DRAINAGE LETTER REPORT
for
WINDERMERE FILING NO. 2

Colorado Springs, CO

June 2024

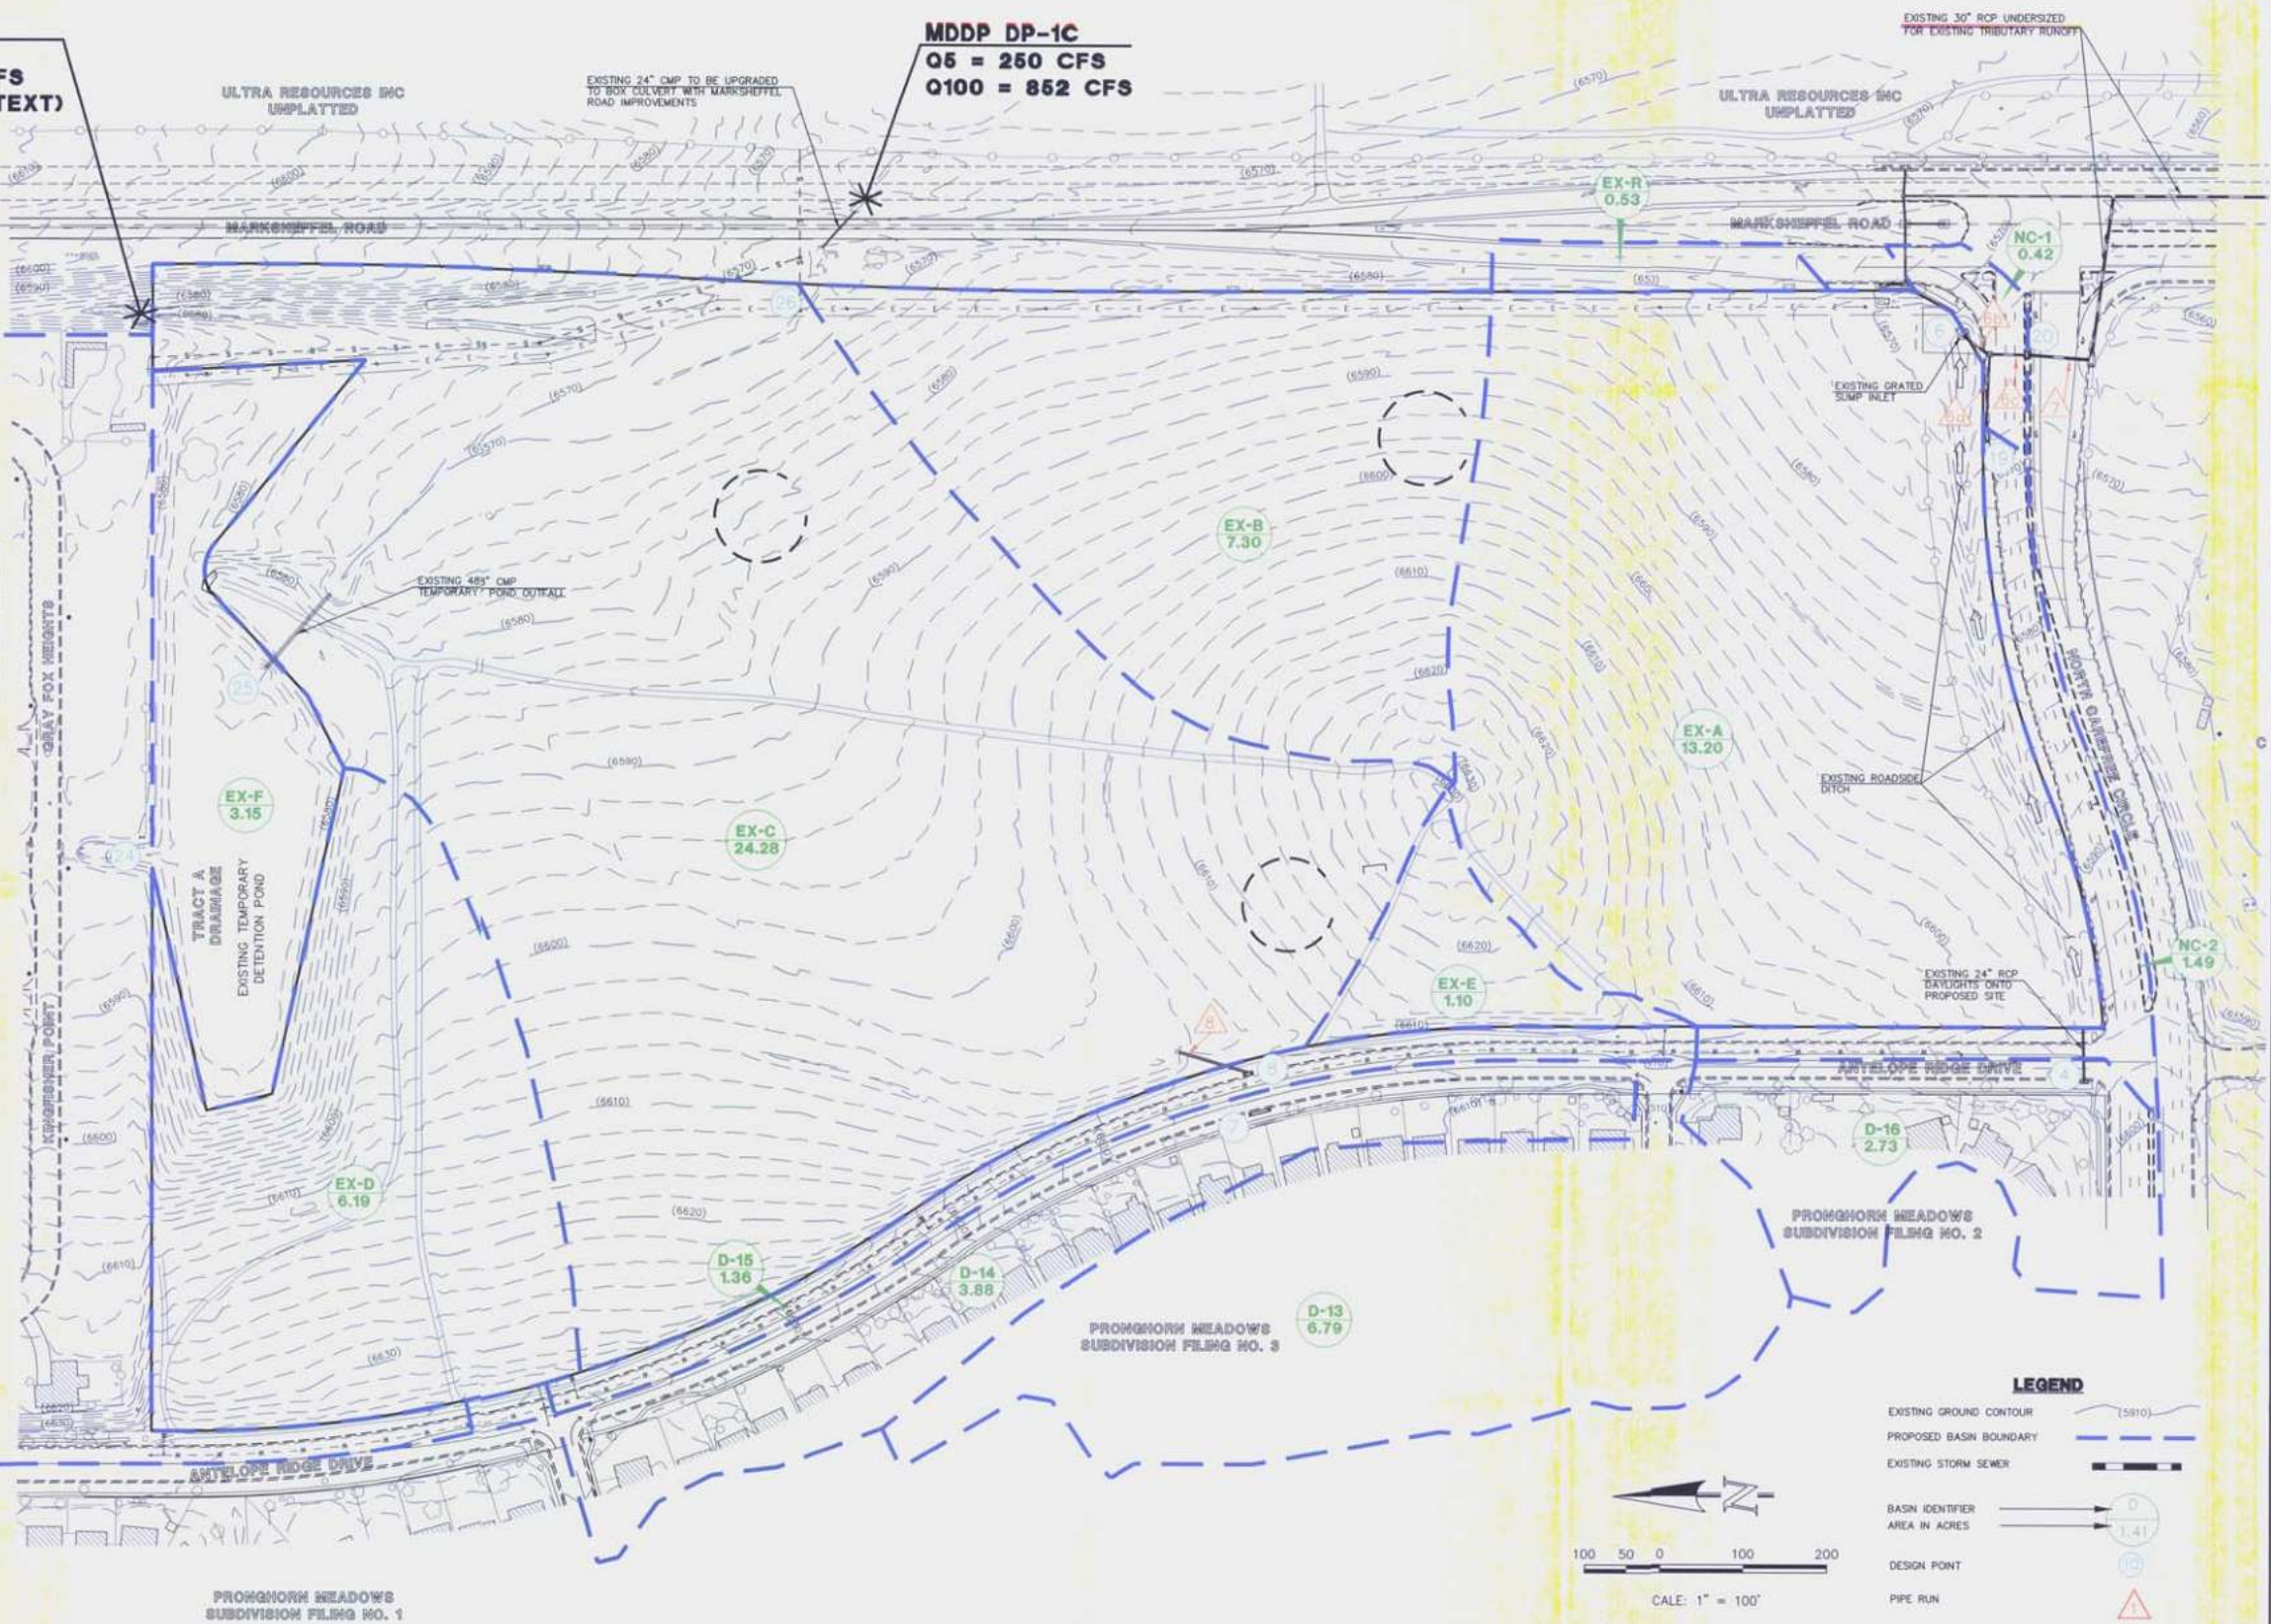
Existing drainage map showing all the existing basins and DP is required. This calculation cannot be reviewed until the map is provided.

PROPOSED DRAINAGE MAP

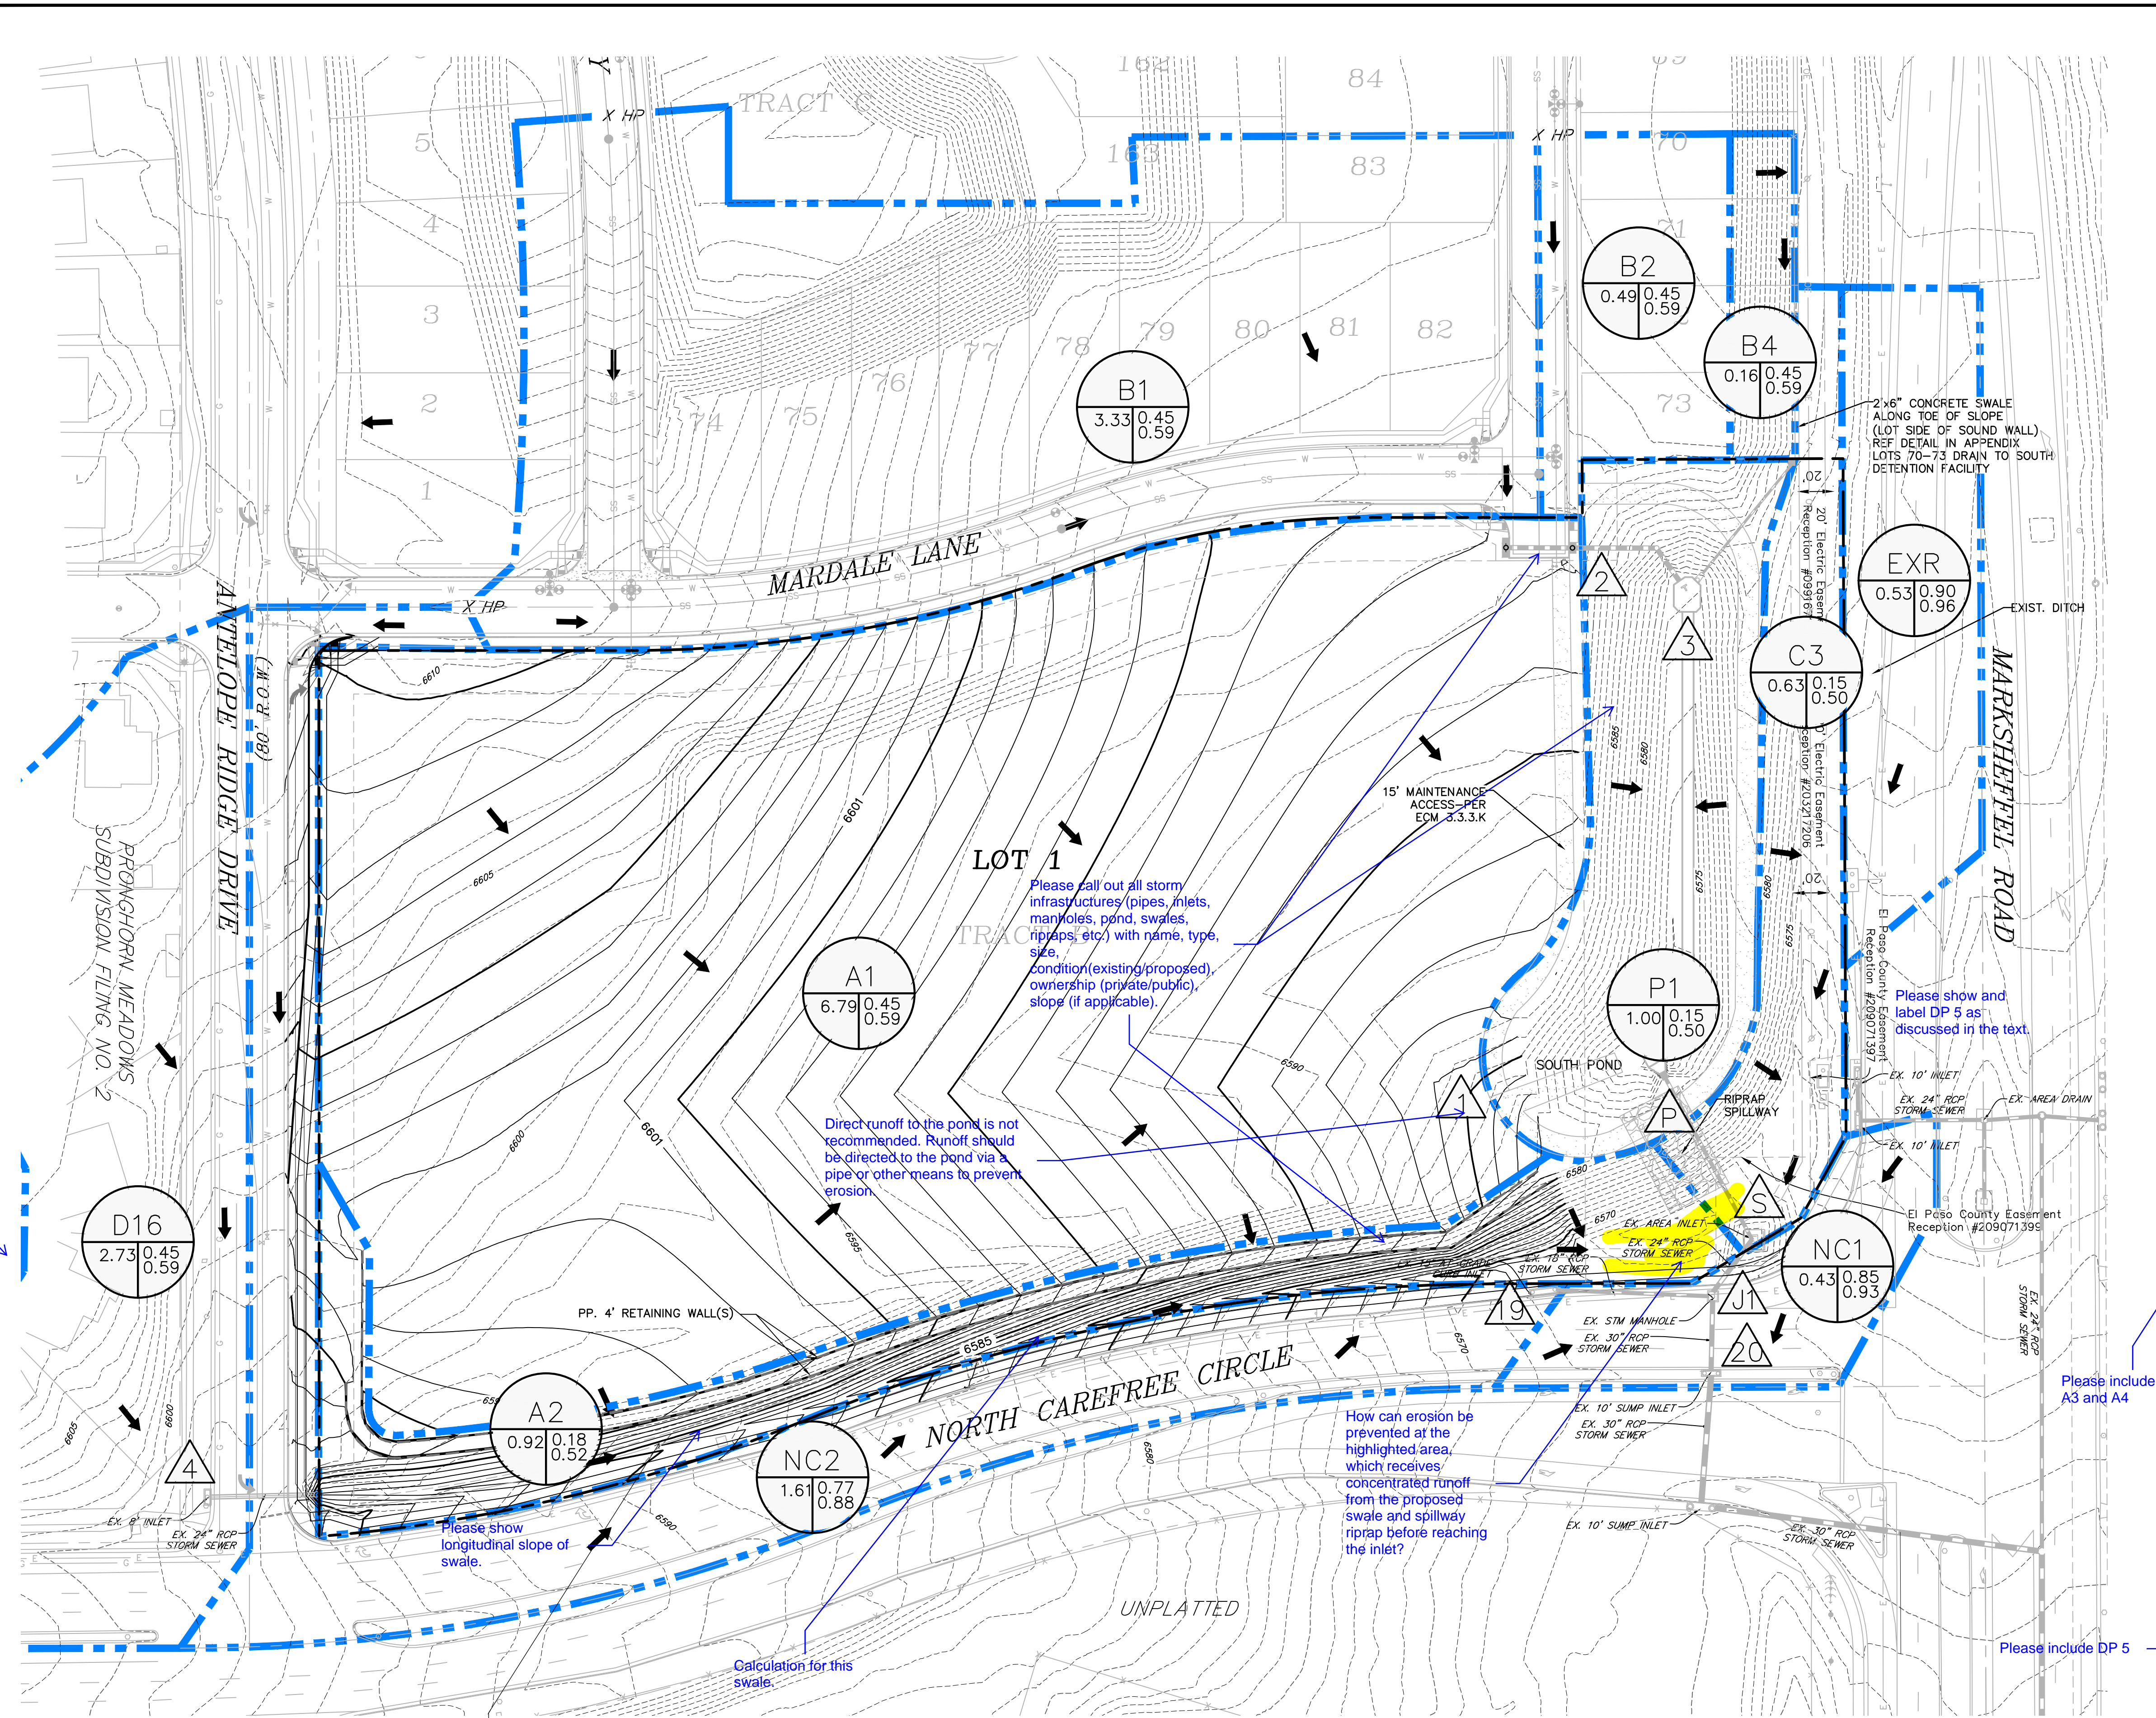
Please expand the map to show the whole basin delineation.

Please call out all storm infrastructures (pipes, inlets, manholes, pond, swales, ripraps, etc.) with name, type, size, condition (existing/proposed), ownership (private/public), slope (if applicable).
